THE GLIDING FEDERATION OF AUSTRALIA

GFA AD 329

AIRWORTHINESS DIRECTIVE

SUBJECT: Unintentional pilot induced oscillation

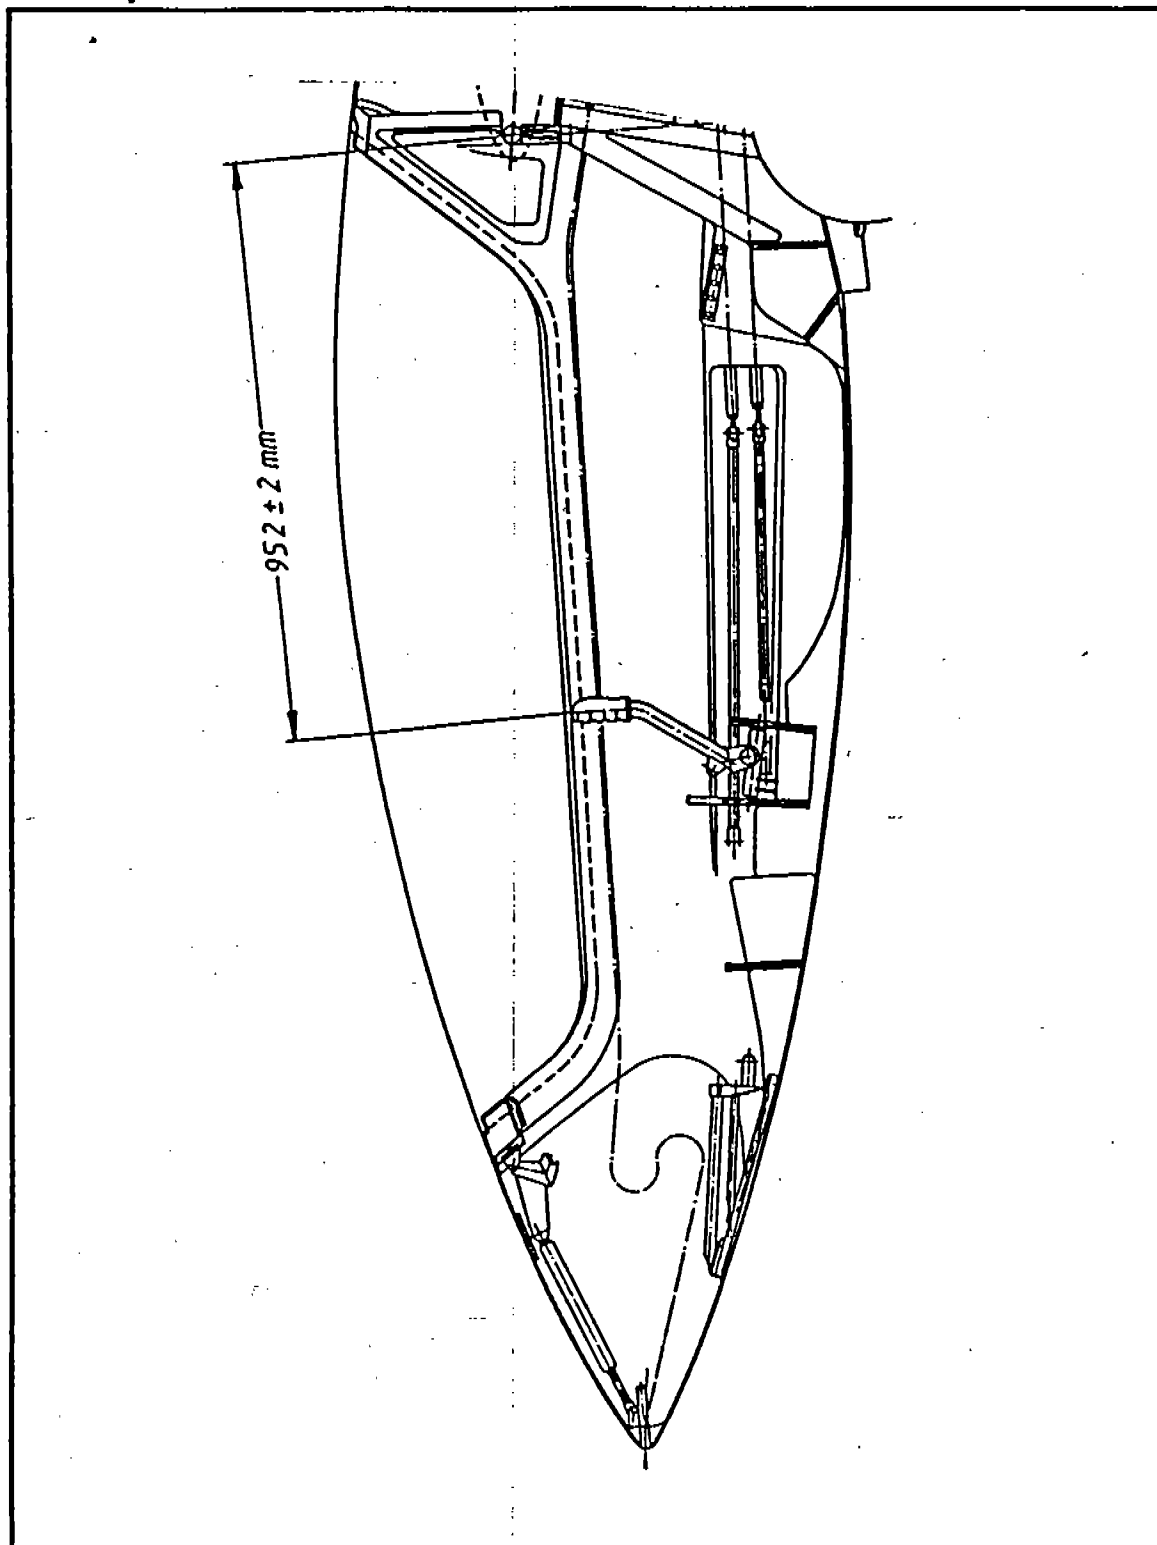
SHEET: 1 of 2	ASW 20 / 20.L Technical Note No.30	Alexander Schleicher <i>Segelflugzeugbau</i> 6416 Poppenhausen
<p><u>Subject:</u> Preventive measure against unintentional PIO (pilot induced oscillations).</p> <p><u>Serial number applicability:</u> All ASW 20 and 20 L, serial no.s 20001 thru 20611.</p> <p><u>Compliance:</u> Accomplishment of the action required under this T.N. until the next annual glider inspection, but at the latest until March 31, 1988.</p> <p><u>Reason:</u></p> <p>Various flight and accidents reports from pilots with little experience with the ASW 20 do indicate that the pilots themselves did induce (unintentionally) pitch oscillations.</p> <p>Besides strong turbulence and rough air the following circumstances - mostly in multiple combinations - were found:-</p> <ol style="list-style-type: none"> 1. Incorrect fastening of safety harnesses. 2. Wrong installation of asymmetric AUTOFLUG-safety harnesses. 3. Soft seat cushions. 4. Loose lead cushions, used in the seat or on the backrest. 5. Rear C.G. positions. 6. Trim untightened. 7. Sticks misplaced to the rear and sticks which are too much cranked. <p>Sticks which are either too much cranked or misplaced too far to the rear, favor PIOs because in rough air the forearm and the hand on the stick are propped up <u>behind</u> the universal joint of the stick and from this unintentional elevator deflections result which still reinforce the maneuvering g-loads.</p> <p><u>Action:</u></p> <ol style="list-style-type: none"> 1. Check that your stick form is identical with the enclosed drawing (200.48.001). Only sticks with this stated crank angle are permissible; sticks differing from that are no longer allowed, even if there should be a previous LBA-approved Modification For A Single Unit for another stick type. Re-install the original stick type. In the case that a brake lever is (to be) fitted to the stick, the extension by means of the wooden compensating piece (200.48.0012) is permissible. 2. Check the most forward position of the stick as per drawing (200.11.S4) and if necessary re-adjust. The adjustment is done at the variable head in front of the stick; for this purpose the elevator must also be in the full down position within the tolerances given in the Operations Manual page 42 (ASW 20) or page 46 (ASW20 L). 3. Remove the existing trim knob; as the landing gear locking mechanism is no more secure while works at the trim are accomplished the seatpan has to be removed also and the fuselage must be jacked up. The new, spring-loaded trim knob must be installed as shown on drawing 200.49.0030. Attention must be paid that the green knurled head screw ① is absolutely locked with the retaining nut ⑦.

SHEET: 2 of 2	ASW 20 / 20 L Technical Note No.30	Alexander Schleicher Segelflugzeugbau 6416 Poppenhausen
<p>With the elevator in the zero position, the trim knob must be adjusted at about 10 mm behind the front edge of the slotted gate; the adjustment is done at the universal joint of the trim spring pot. Finally check that all parts are free-moving and re-install the seatpan.</p> <p>4. If the 4-part, asymmetric AUTOFLUG safety harness (consisting of shoulder harness FAG 7B-1, and lap belt FAG 7K-1) is installed in your glider, it must be checked whether the short lap belt member is mounted at the <u>right</u> cockpit wall (in flight direction) and is diagonally opposite to the long shoulder harness which is mounted at the main bulkhead close to the red parachute static line anchoring ring. Only then the prescribed position to strap oneself in can be achieved.</p> <p>5. Exchange the following pages in the respective Flight and Operations Manuals:- ASW 20: p. 13, 19, 20, and 38; ASW 20 L: p. 14, 20, 21, and 42; for pages with the same numbers but with the reference entry of T.N. no.30 dated 01.04.87. These pages give important notes for preventing PIO.</p> <p>6. The exchange of the pages in the Manuals must be documented on page 4 "Amendments to the Manual".</p> <p><u>Material & drawings:</u> See drawings: 200.11.54; 200.48.0001; 200.48.0012; and 200.49.0030. Manual pages as stated under above para ACTION, points 5 & 6.</p> <p><u>Mass and C.G.:</u> The influence of this mod is negligible.</p> <p><u>Notes:</u> This action can be accomplished by a competent person. The accomplishment of this mod must be inspected by an aviation inspector holding the appropriate license and certified in the glider logbook and in the inspection certificates.</p>
